Concerns with Increasing the Wavelength Range for 100GBase-FR1/LR1

Brian Welch

Wavelength Sensitivity of Optical Receivers

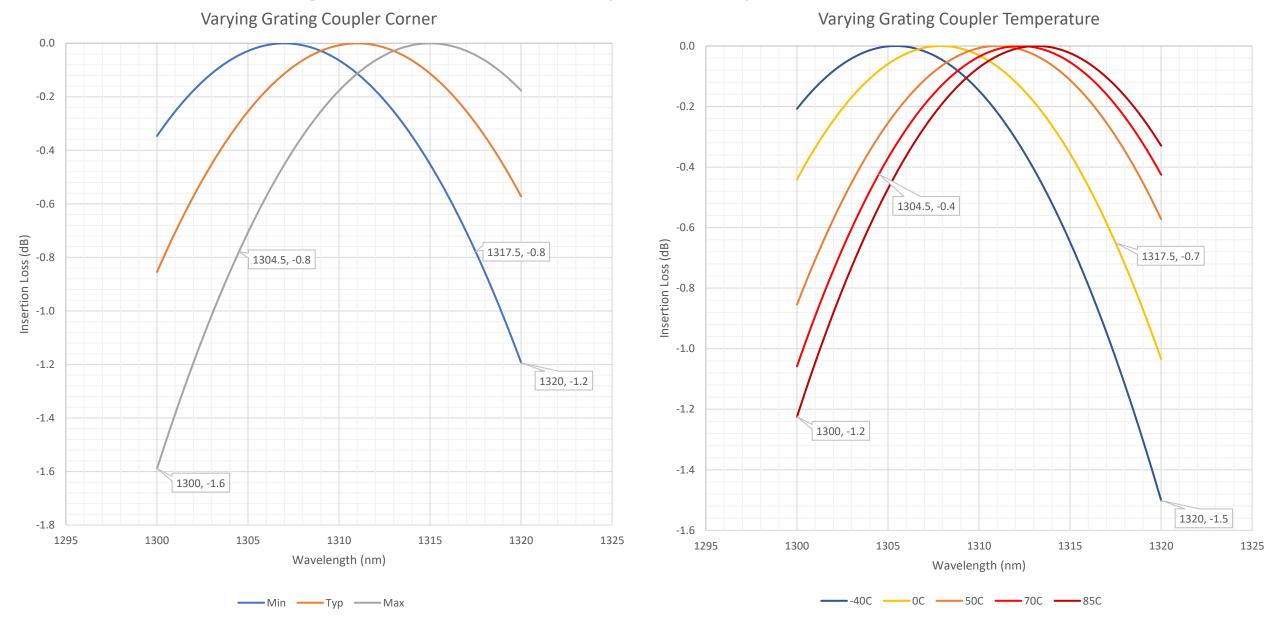
- Key assumption in <u>chuang 3cu 01a 091520.pdf</u> was that <u>only</u> the photodiode had wavelength dependency in the receiver.
- Wavelength dependence can be present in components beyond photodiode:
 - Silicon Photonic Grating Couplers
 - Discrete optics couplers (including AR coating applications)
- Degradations of ≥ 1dB possible if expanding from 13nm to 20nm optical bandwidths if design was optimized to IEEE specifications
